UNITED STATES DEPARTMENT OF COMMERCE United States Patent and Trademark Office Addiese: COMMISSIONER FOR PATENTS P O Box 1450 Alexandra, Virginia 22313-1450 www.wepto.gov

Application No. Applicant(s) 10/538.542 AEBI ET AL. Office Action Summary Examiner Art Unit MICHAEL T. SCHAPER 3775 -- The MAILING DATE of this communication appears on the cover sheet with the correspondence address --Period for Reply A SHORTENED STATUTORY PERIOD FOR REPLY IS SET TO EXPIRE 3 MONTH(S) OR THIRTY (30) DAYS. WHICHEVER IS LONGER, FROM THE MAILING DATE OF THIS COMMUNICATION. Extensions of time may be available under the provisions of 37 CFR 1.136(a). In no event, however, may a reply be timely filed after SIX (6) MONTHS from the mailing date of this communication. If NO period for reply is specified above, the maximum statutory period will apply and will expire SIX (6) MONTHS from the mailing date of this communication - Failure to reply within the set or extended period for reply will, by statute, cause the application to become ABANDONED (35 U.S.C. § 133). Any reply received by the Office later than three months after the mailing date of this communication, even if timely filed, may reduce any earne

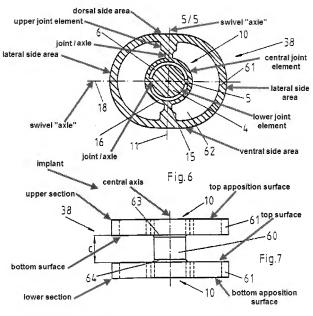
Frigg discloses an intervertebral implant (see examiner-annotated Figs. 6-7 above) comprising a central axis, an upper section, suitable for laying onto the base plate of a vertebral body lying above, and a lower section suitable for laying onto the cover plate of a vertebral body lying below, wherein the upper section has a ventral side area, a dorsal side area, two lateral side areas, a top apposition surface, and a bottom

surface; the lower section has a ventral side area, a dorsal side area, two lateral side areas, a bottom apposition surface, and a top surface; and the two sections are moveable in relation to each other via two joints arranged between the two sections, wherein each of the joints has a swivel axle and the two swivel axles are arranged transversely or perpendicular to each other; the two joints comprise an upper joint element connected with the upper section, a central joint element, and a lower joint element connected with the lower section; the central joint section is connected with the lower joint section by means of at least one axle coaxial to the swivel axle and rotating around the swivel axle and with the upper joint section by means of at least one axle coaxial to the swivel axle and rotating around the swivel axle; wherein the central joint element comprises a frame; wherein the central joint element is in the form of a cross; wherein the central joint element is in the form of an angle.

Frigg discloses the claimed invention except for a means being provided that is suitable for causing temporary blocking of the mobility of the two sections around the joint, whereby that the means comprises an insert with a lower end and an upper end and a depression in the surfaces at each of the two sections, which are open on the ventral side areas, and that the insert with its ends can be inserted into each of the depressions; wherein the means keeps the two sections, measured at their ventral side areas, at a fixed distance from each other; wherein the means can be attached to the two ventral side areas of the two sections; wherein the depressions are dovetail guides and the ends on the insert are arranged complementary to these dovetail guides; wherein the dovetail guides are tapered from the ventral side areas towards the dorsal
